**MIRAGE CINEMA AND DICE RETAIL PRO
JZ18-33 with Rezoning 18.726**

MIRAGE CINEMA AND DICE RETAIL PRO JZ 18-33 AND ZONING MAP AMENDMENT 18.726

Recommendation to the City Council for approval or denial or postponement of the rezoning request from OS-1 (Office Service) and B-3 (General Business) to B-2 (Community Business) with a Planned Rezoning Overlay Concept Plan.

PLAN REVIEW CENTER REPORT

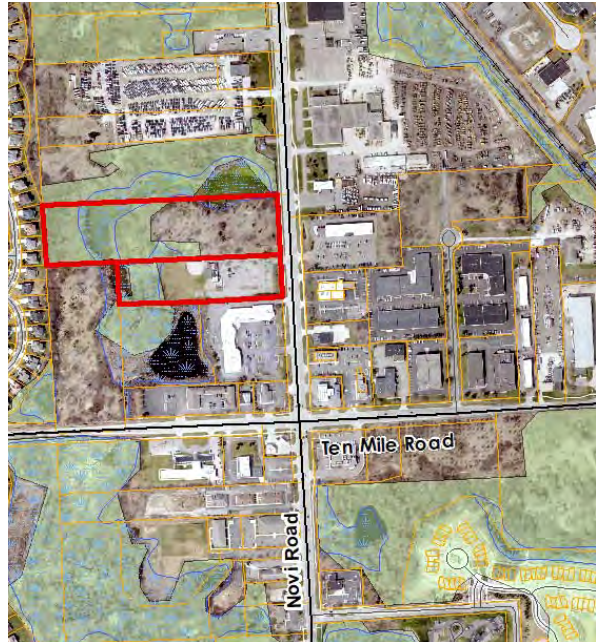
Engineering: The review noted that the Concept Plan meets the general requirement of Chapter 11 of the Code of Ordinances. Storm water would be collected by a single storm sewer collection system and detained in a proposed storm water basin on the site of the movie theater.

The northeast portion of the development is proposed to discharge directly to adjacent wetlands rather than being conveyed to the proposed on-site detention basin.

The plan would require revisions to make sure that runoff from the entire development is captured and detained prior to discharge. Alternative options are discussed in the Engineering review.

Figure 1. City of Novi Regulated Wetland & Woodland Map (approximate parcel boundary shown in red). Regulated Woodland areas are shown in green and Regulated Wetland areas are shown in blue.

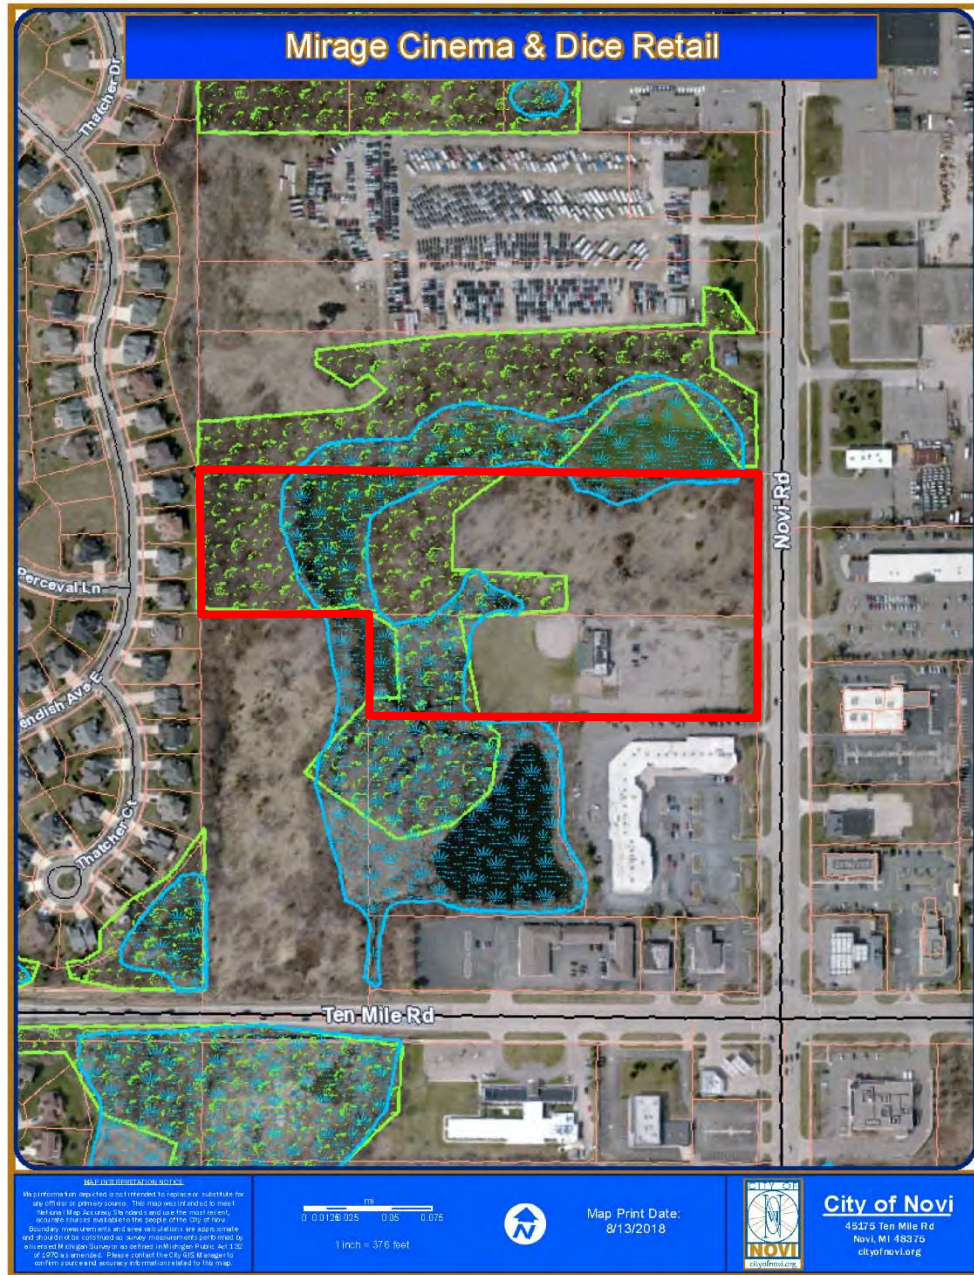
Based on our review of the application, Novi aerial photos, Novi GIS, the City of Novi Official Wetlands and Woodlands Maps (see Figure 1, attached), and our wetland verification site inspection conducted on June 19, 2018 it appears as if this proposed project site contains areas mapped as City-Regulated Wetlands/Watercourses. The site appears to contain wetland/watercourse areas that are regulated by the City of Novi as well as the Michigan Department of Environmental Quality (MDEQ). The focus of the site inspection was to review site conditions in order to determine whether City-regulated wetlands are found on-site.

Currently, the Plan appears to indicate one (1) direct impact to on-site wetlands. This impact is located in the northeast portion of the project site where a stormwater outfall to wetland is proposed from the parking area (storm sewer structure #11, shown on Sheet C4, *Preliminary Utility Plan – Sheet 1*). It appears as if site stormwater will discharge to existing wetland in this area of the site after passing through a proposed manufactured treatment structure. The Plan notes that this is to be designed during the engineering phase.

Figure 1. City of Novi Regulated Wetland & Woodland Map (approximate parcel boundary shown in red). Regulated Woodland areas are shown in green and Regulated Wetland areas are shown in blue.

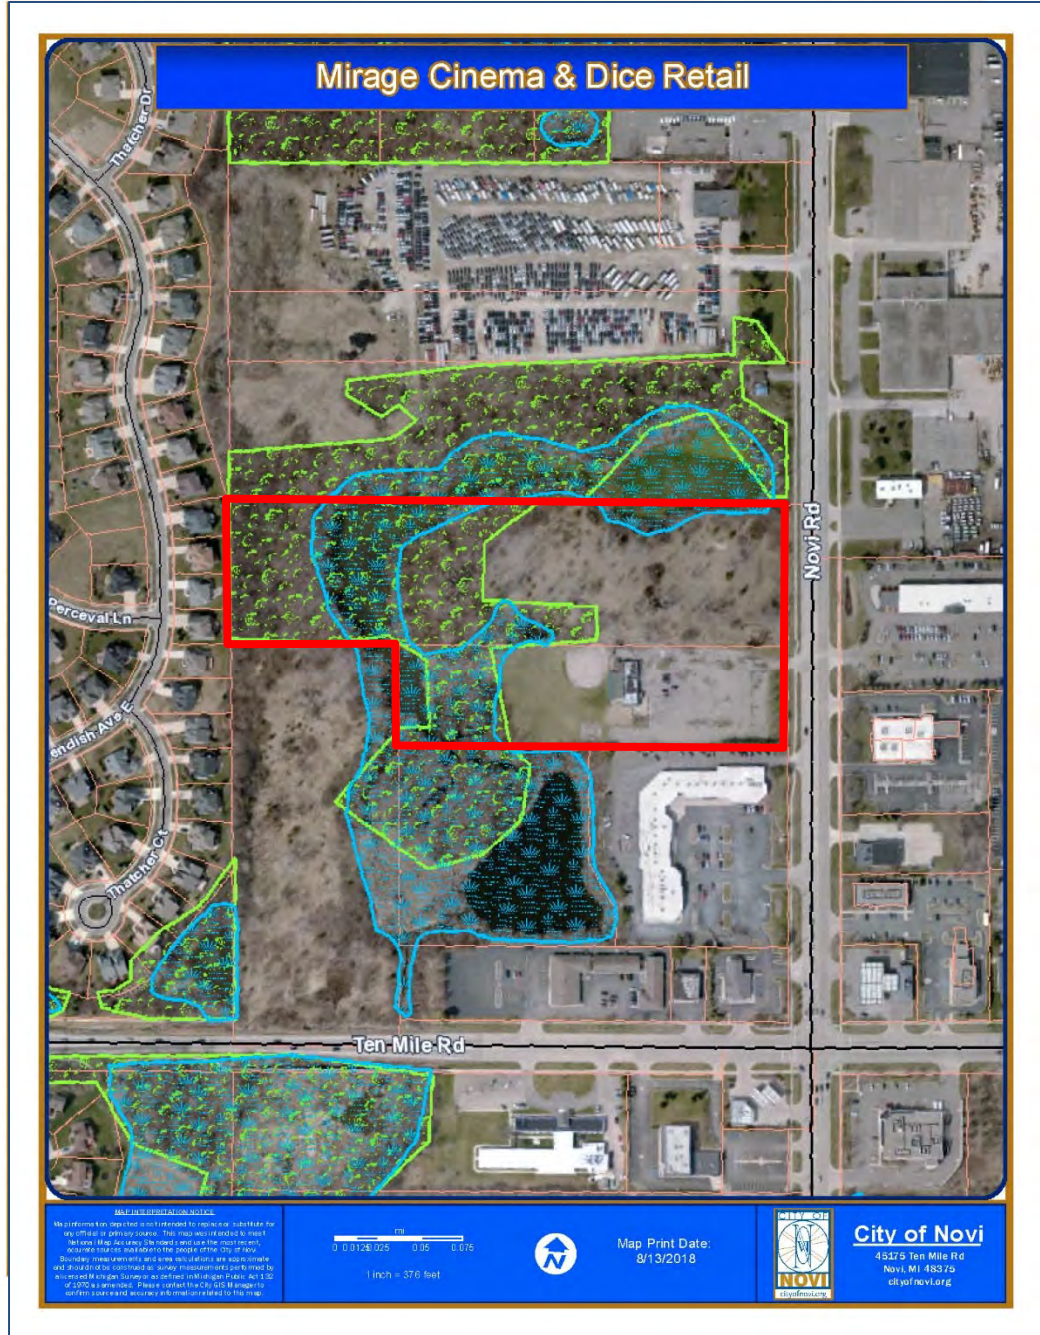
Based on our review of the Plan, Novi aerial photos, Novi GIS, City of Novi Official Wetlands and Woodlands Map (see Figure 1), and on-site evaluation this proposed project site contains areas indicated as Regulated Woodlands as well as Regulated Wetlands. The western portion of the southern parcel, and the western 1/2 of the northern parcel are mapped as containing City-regulated woodland.

1. ECT encourages the Applicant to minimize impacts to on-site woodlands to the greatest extent practicable. Currently, the Plan proposes to remove **106** of the regulated **114** trees (93% of the on-site regulated trees). The current required Woodland Replacement Credit quantity is **159** Woodland Replacement Credits.
2. The applicant shall add a ‘remove/save’ column to the Tree Inventory List on Sheet C1. In addition, for trees proposed for removal, the Tree Inventory List should include a column indicating the number of Woodland Replacement Credits Required.
3. The applicant should clearly indicate on the Plan if existing trees are proposed for removal. The Applicant shall report the number of trees that are proposed to be removed within the following categories and indicate how many Woodland Replacement are required for each removed tree:
